Access Compliance Report

Public Rights-of-Way

(Curb Ramps)

Intersection ID: 10030162	Main Street: LATHAM_PL	Cross Street: N/A	Location: N
ADA ID: 7D29D11D2B7B	Ramp Type: Perp	Initial Pass/Fail: Fail	Overall Compliance: No
Severity Score: 8.75			
Codes/Mitigation Info/Possible Solution		Field Measurements/Component Compliance

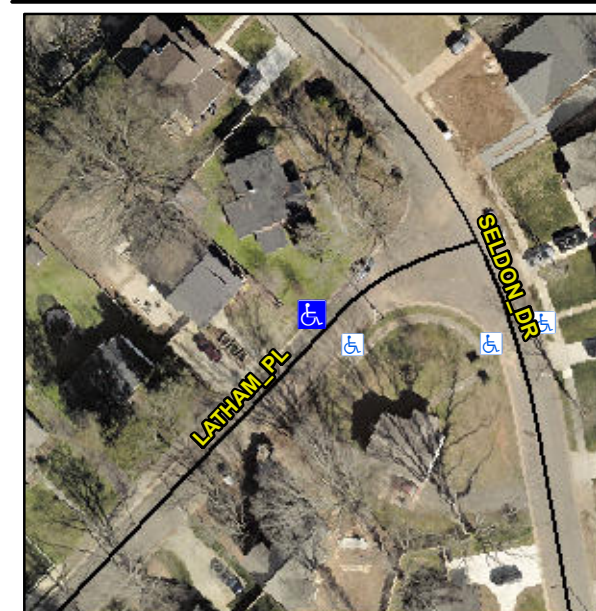
Not Found, R304.5.1

Compliance	Description	Data	Compliance	Description	Data
N/A	Ramp Length (in)	83.0	Yes	Ramp Slope (%)	5.0
No	Ramp Width (in)	47.0	Yes	Ramp XSlope (%)	1.7
N/A	Flare Type LT	N/A	N/A	Flare Type RT	N/A
N/A	Flare Slope LT (%)	N/A	N/A	Flare Slope RT (%)	N/A
N/A	Flare Traversable LT?	N/A	N/A	Flare Traversable RT?	N/A
N/A	Landing Length (in)	N/A	N/A	DWS Provided?	N/A
N/A	Landing Width (in)	N/A	N/A	DWS Contrast?	N/A
N/A	Landing Slope (%)	N/A	N/A	DWS Length (in)	N/A
N/A	Landing X Slope (%)	N/A	N/A	DWS Full Width?	N/A
N/A	Landing Curb? (Y/N)	N/A	N/A	DWS Offset (in)	N/A
N/A	Shared Landing?	N/A			
N/A	Gutter Ponding?	Yes	N/A	Gutter Slope (%)	N/A
N/A	Gutter Lip Ht (in)	0.8	N/A	Gutter X Slope (%)	N/A
N/A	Painted X Walk1?	No	N/A	Painted X Walk2?	N/A
	X Walk 1 Direction	To SE		X Walk 2 Direction	N/A
N/A	X Walk 1 Width (in)	N/A	N/A	X Walk 2 Width (in)	N/A
	X Walk 1 Slope (%)	4.3		X Walk 2 Slope (%)	N/A
	X Walk 1 X Slope (%)	0.1		X Walk 2 X Slope (%)	N/A

Remove & Replace Entire Ramp.
